Access Compliance Report Public Rights-of-Way (Curb Ramps)

Intersection ID: 10040592 Main Street: W_ARROWOOD_RD Cross Street: N/A Location: NE

ADA ID: 06471BA3272D Ramp Type: Perp Initial Pass/Fail: Fail Overall Compliance: No Severity Score: 12.5

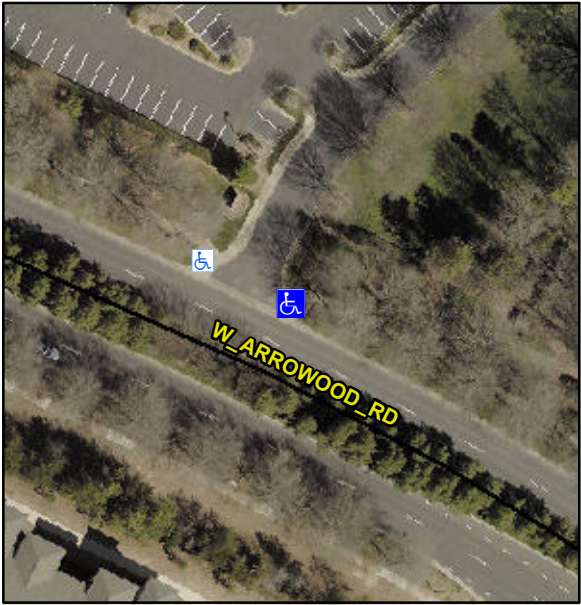
PROW/ADA:
Not Found, R304.2.2

Compliance	Description	Data	Compliance	Description	Data
N/A	Ramp Length (in)	64.5	No	Ramp Slope (%)	8.7
Yes	Ramp Width (in)	60.0	Yes	Ramp XSlope (%)	0.5
N/A	Flare Type LT	N/A	N/A	Flare Type RT	N/A
N/A	Flare Slope LT (%)	N/A	N/A	Flare Slope RT (%)	N/A
N/A	Flare Traversable LT?	N/A	N/A	Flare Traversable RT?	N/A
N/A	Landing Length (in)	N/A	N/A	DWS Provided?	N/A
N/A	Landing Width (in)	N/A	N/A	DWS Contrast?	N/A
N/A	Landing Slope (%)	N/A	N/A	DWS Length (in)	N/A
N/A	Landing X Slope (%)	N/A	N/A	DWS Full Width?	N/A
N/A	Landing Curb? (Y/N)	N/A	N/A	DWS Offset (in)	N/A
N/A	Shared Landing?	N/A			
N/A	Gutter Ponding?	N/A	N/A	Gutter Slope (%)	N/A
N/A	Gutter Lip Ht (in)	N/A	N/A	Gutter X Slope (%)	N/A
N/A	Painted X Walk1?	No	N/A	Painted X Walk2?	N/A
	X Walk 1 Direction	To NW		X Walk 2 Direction	N/A
N/A	X Walk 1 Width (in)	N/A	N/A	X Walk 2 Width (in)	N/A
	X Walk 1 Slope (%)	0.1		X Walk 2 Slope (%)	N/A
	X Walk 1 X Slope (%)	11.8		X Walk 2 X Slope (%)	N/A

Possible Solutions:
Remove & Replace Entire Ramp.
